EPC STORMWATER REVIEW COMMENTS  
IN ORANGE BOXES WITH BLACK TEXT

# FINAL DRAINAGE REPORT

## FOX RUN NATURE CENTER & ROAD RECLAMATION PROJECT

PPR2349

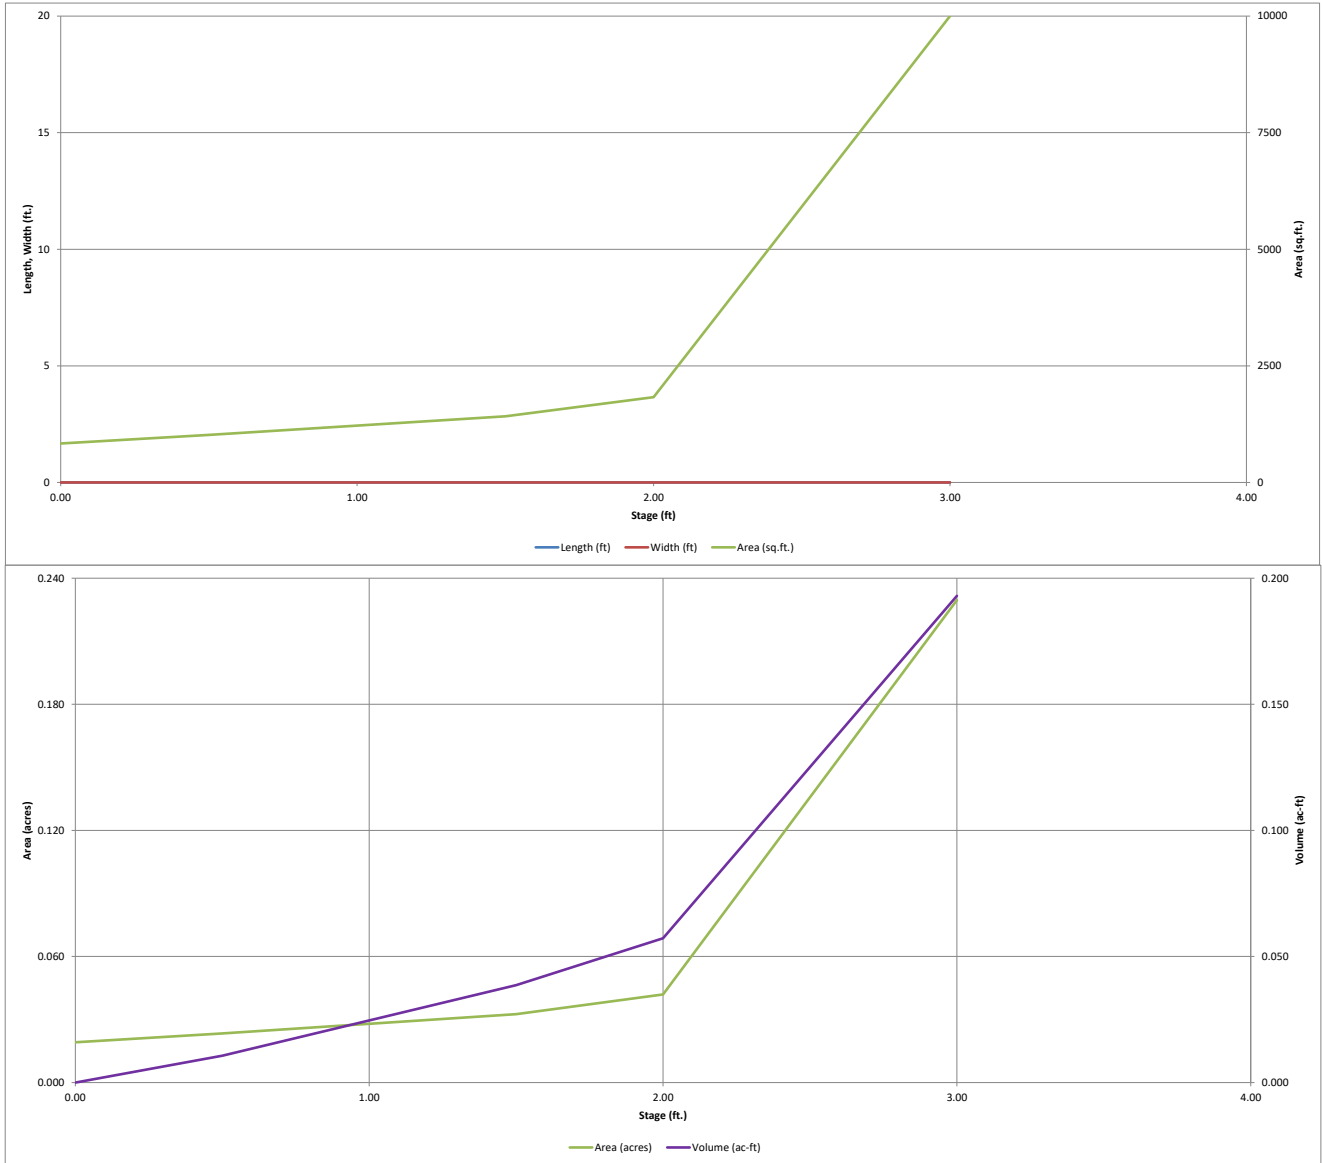
Since soils for this project are known, make this a less generic statement. State the exact depth of the top of elbow for this project. And show this depth of CDs.

But why does the depth of the top of the elbow even matter? Because on the CDs it is shown as capped. The only depth that matters is the depth/elev of the orifice hole. Did you mean orifice hole instead of top of elbow? Please clarify.

EL PASO COUNTY  
UNINCORPORATED  
**FOX RUN NATURE CENTER**  
2108 STELLA DRIVE  
PROPOSED CONDITIONS DETAIL MAP

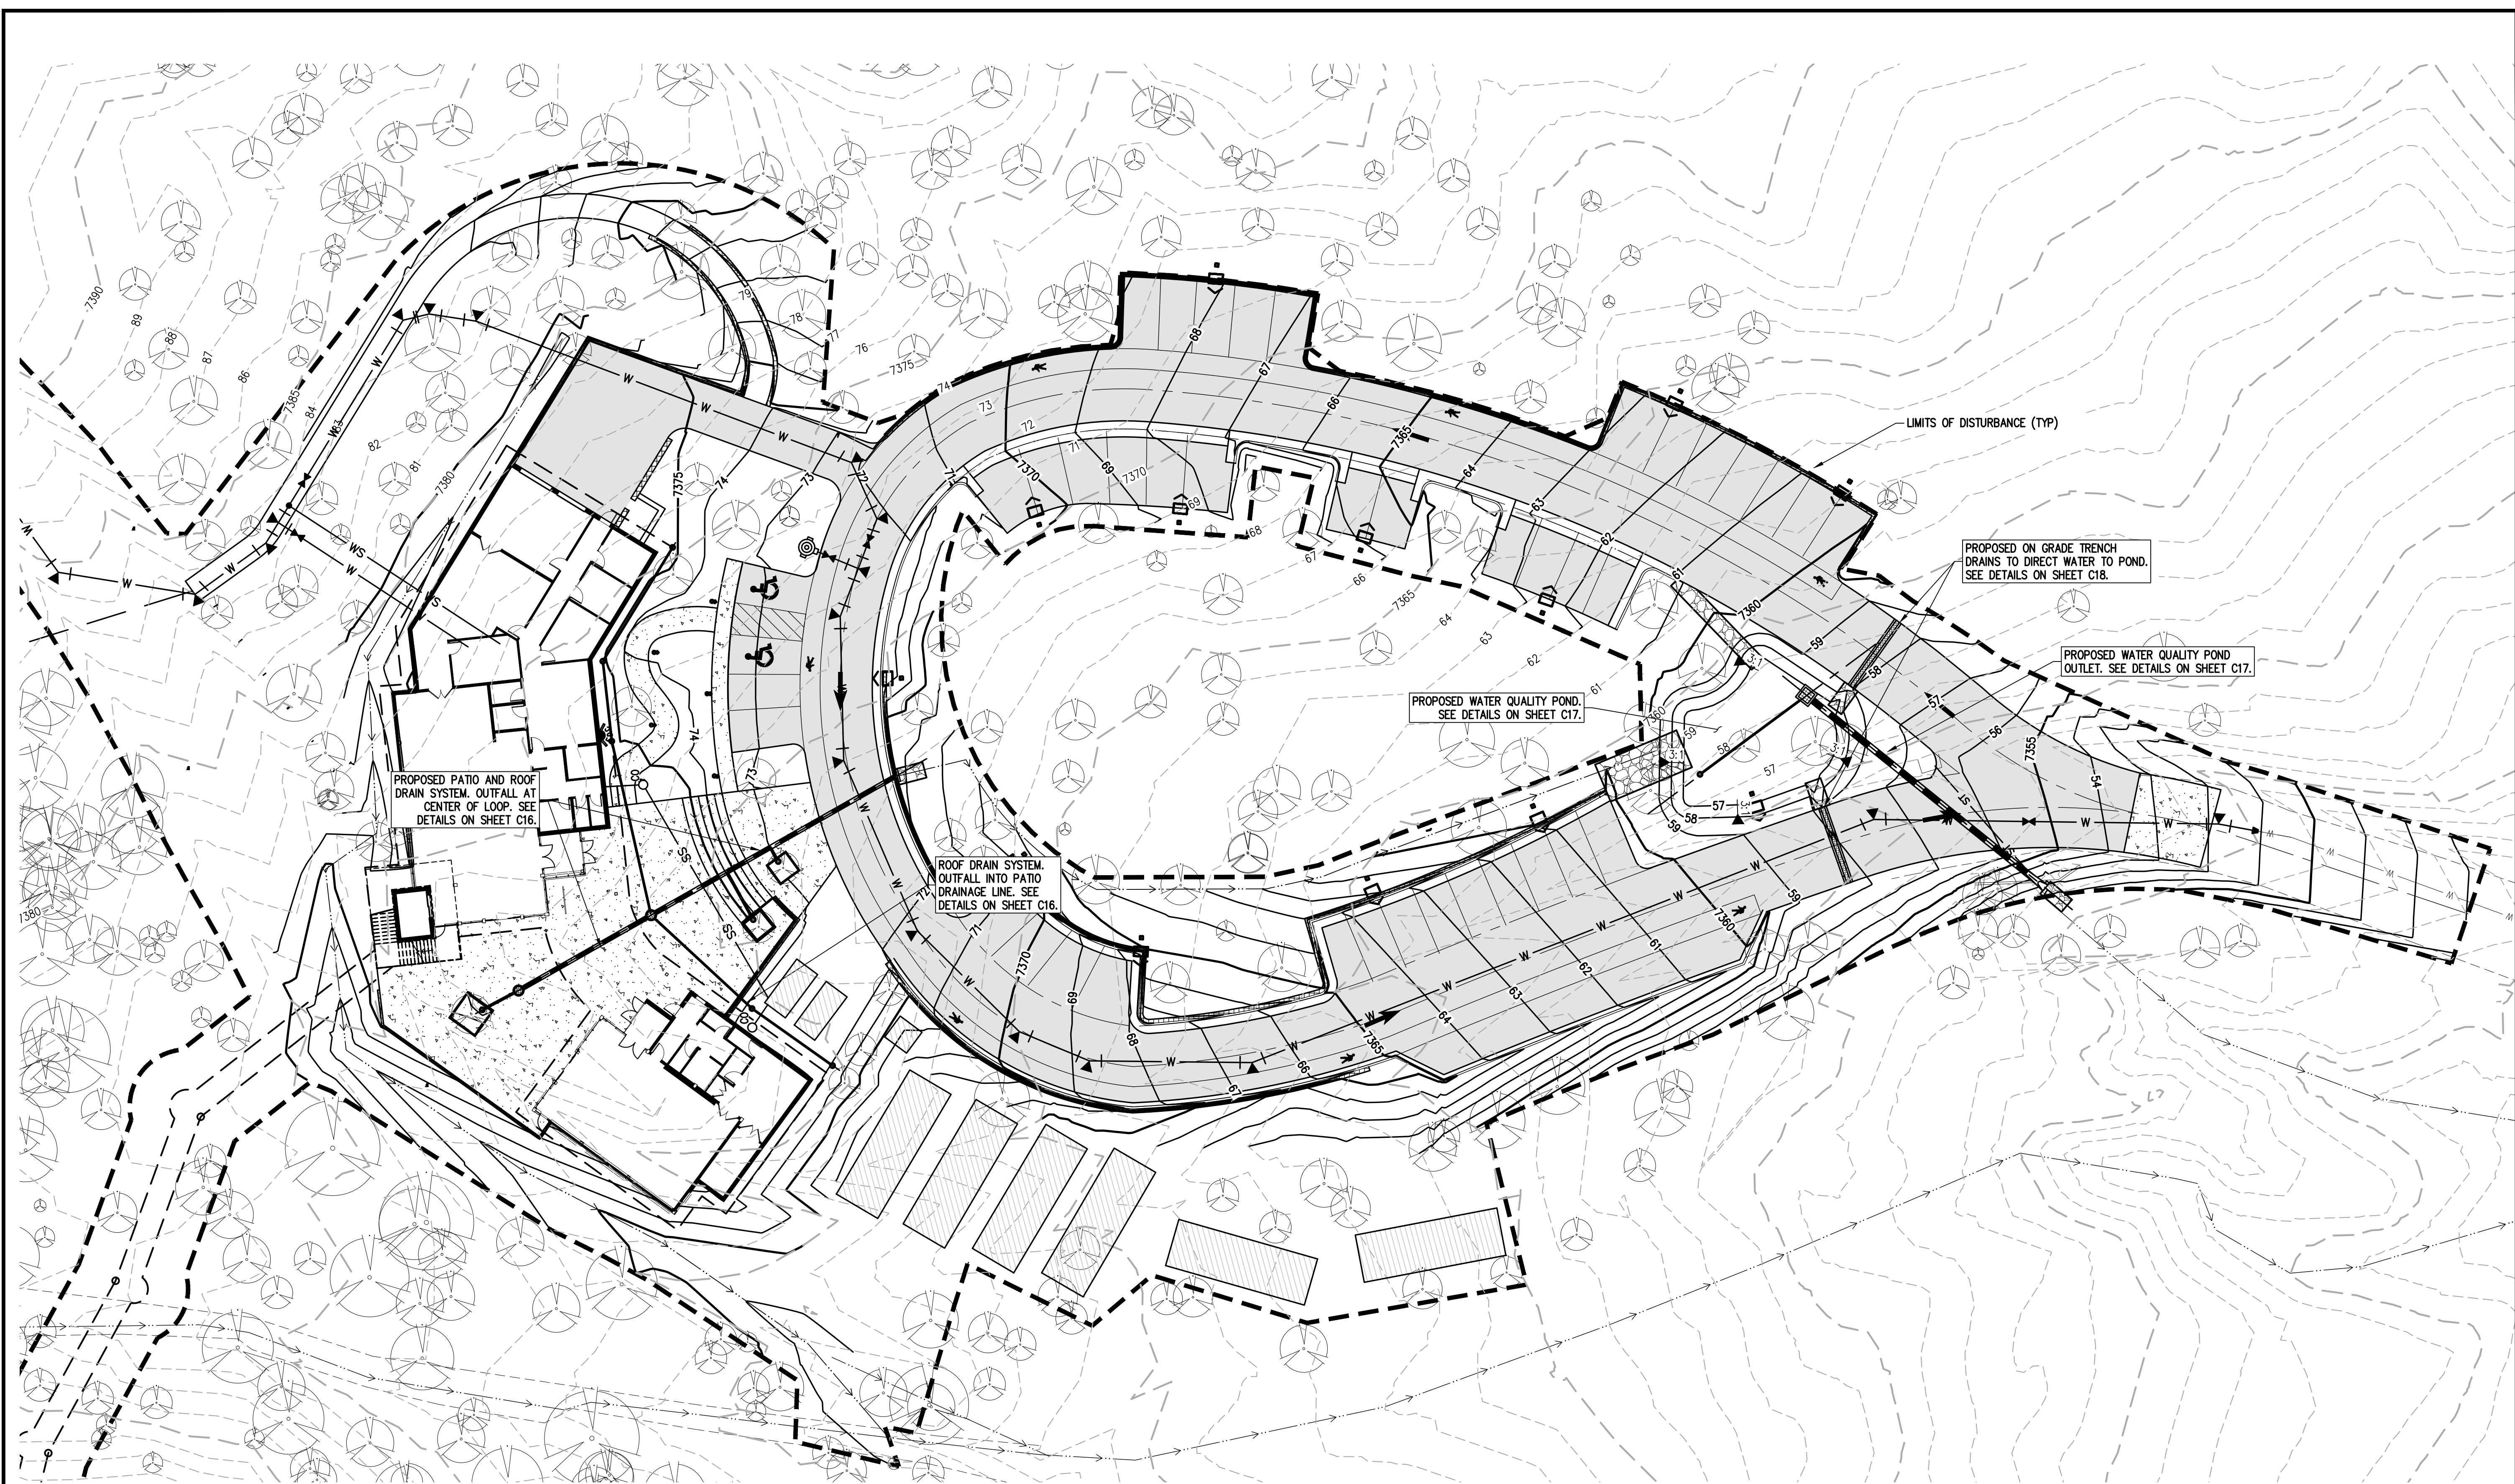
Include label
